PLAN 7

PLANNING APPLICATION PLN-20-0167

158 WELLINGTON STREET, LONGFORD

ATTACHMENTS

NORTH WEST DRAWING ELEVATION

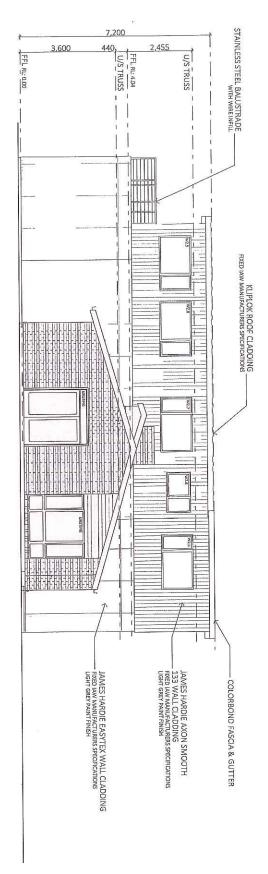
The dimensions of the garage opening are 7m wide (approx. 6m shown on the drawings and renders) by 3.3m high. This is significantly greater than typical of residential developments and does not appear to have been designed in a way which minimises the dimensions.

Artist impressions are indicative only and not drawn to any specific scale, as indicated on the plans. In addition to this, 10.4.5 A1 states that the garage opening width can be a maximum of 6 metres. As our proposed garage opening width is 7m this is only 1 metre greater than the acceptable solution, and there is no requirement listed in the relevant performance criteria stating that the width of the garage has to match the width that is 'typical of residential developments'.

DRAWING ELEVATION SOUTH EAST

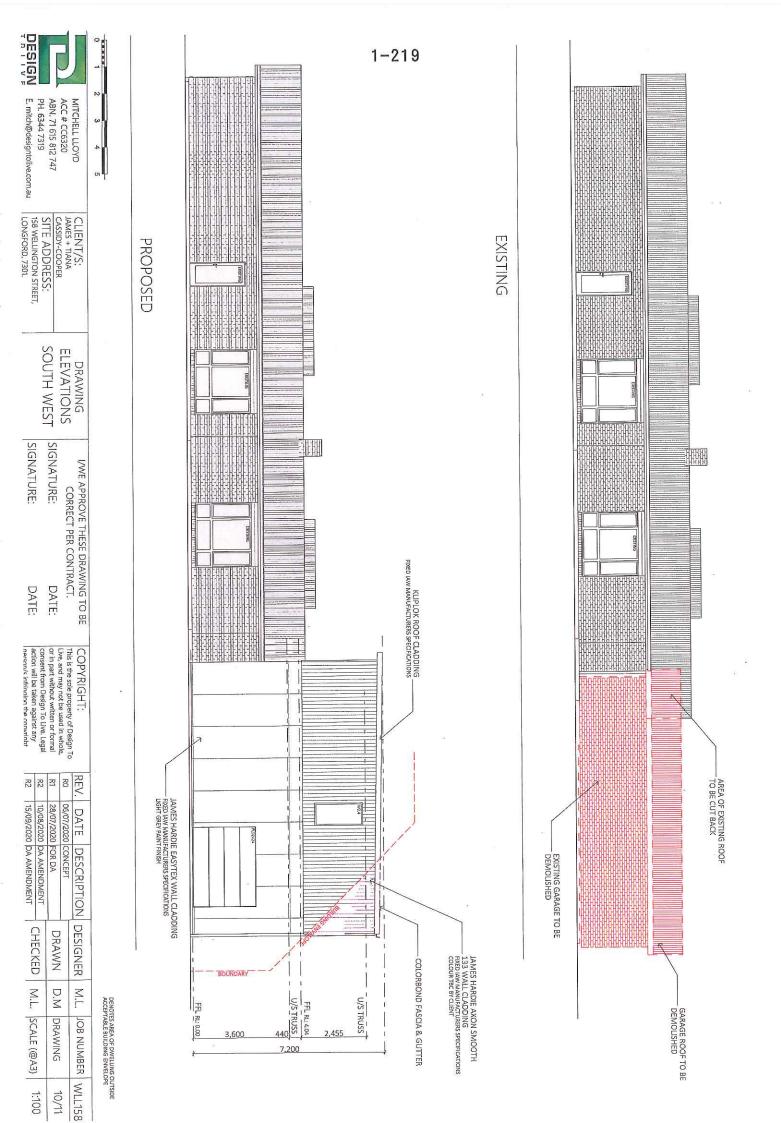
It is equally unclear how vegetation of approximately 5m in height could sufficiently screen the visual impact caused by the proposed extension which has an overall height of approximately 7.3m to ground level (7.2m shown on drawings is to finished floor level). Given the overall scale of the proposed extension, it is likely to dominate the skyline when viewed from adjoining properties (and beyond) and therefore does not adequately satisfy the requirements of 10.4.2 P3 (a) (iv).

The height of the existing vegetation is not relevant in relation to the total height of the proposal. As seen in Diagram 10.4.2A the allowable building envelope has a maximum height of 8.5m. The proposed development height is well contained within this height. The only area that protrudes the building envelope is in the south west corner of the development which is already indicated on the elevations (see pages WLL158-9 & WLL158-10). Refer to cover letter for further information.
